Architectural Review Board Staff Report

Meeting Date: December 8, 2022

Location: 17017 N. Outer 40 Road

Description: The District (ASDP): An Amended Site Development Plan, Landscape Plan, Lighting Plan, Architectural Elevations, and Architect's Statement of Design located on a 48.15-acre tract of land located north of N. Outer 40 Road and east of Boone's Crossing, zoned "PC" – Planned Commercial.

Figure 2: Updated South Elevation

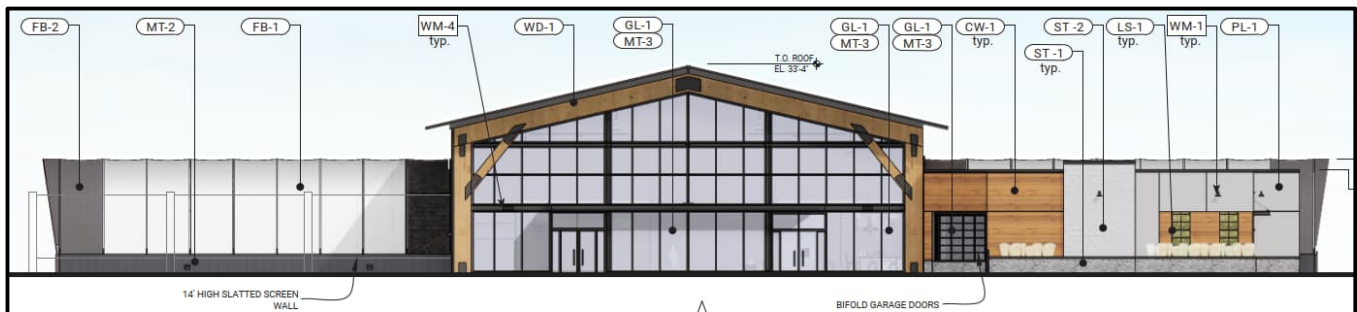
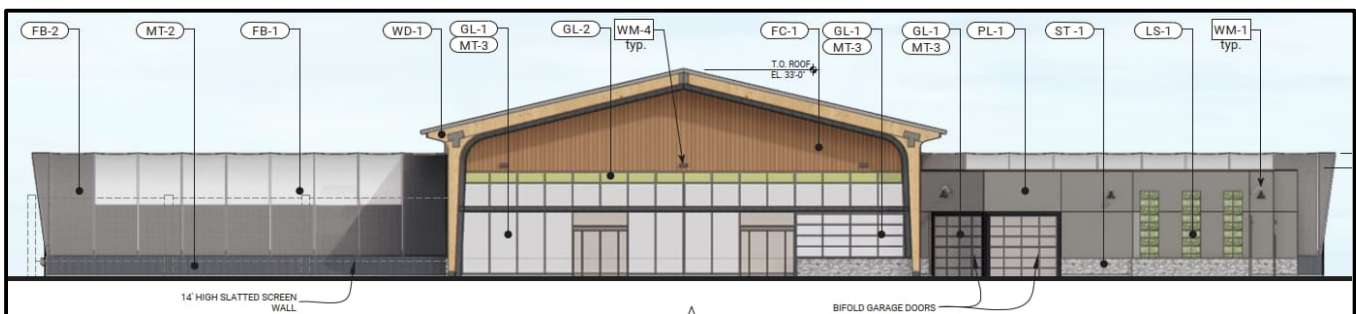
Since the last time the project was reviewed, the applicant has made changes to materials on all elevations. The south elevation (facing I-64) of the main building was predominantly wood composite paneling. The wood composite paneling has been removed and replaced with a glass curtain wall. The west elevation of the main building, which also previously utilized the wood composite paneling, is now wood shingles. The wood shingles are also utilized on bands of the domed structures and the north elevation of the main building (facing the Levee trail).

One of the concerns expressed at the previous meeting was that the development felt disconnected or not cohesive with the remainder of The District. The applicant stated they explored making modifications to the proposed gable roof to accommodate a more cohesive feel, however, the gable roof and the structural components associated with it are ideal for the intended use of the building. The updated south elevation (facing I-64) and the previously reviewed south elevation can be found below. The other three updated elevations can be found in the applicant's updated packet.

Figure 3: South Elevation (as seen from I-64/40)

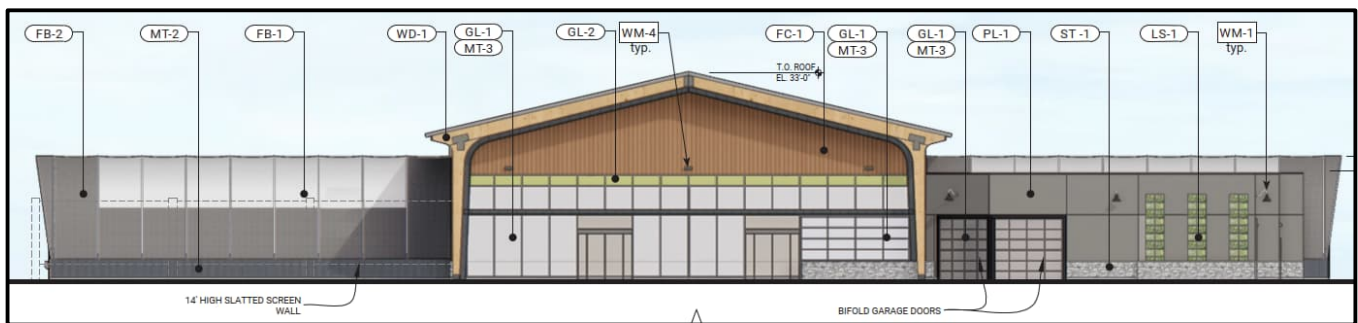
The applicant is proposing a mixture of composite wood panel and painted plaster for the main building. It will also feature accents of stone veneer around the base and glass garage doors on the south façade facing I-64/40.

Figure 4: North Elevation (as seen from Levee Trail)

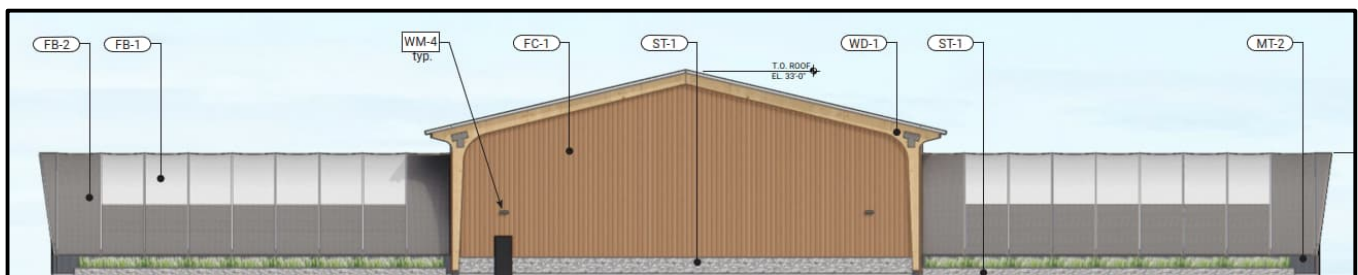
The south façade facing I-64/40 will feature four (4) decorative wall mounted fixtures. The west and north facades will feature fully cut off wall packs while the east façade will utilize a similar wall pack but is not described as being fully cut off. The illumination levels of all wall mounted fixtures are code compliant.
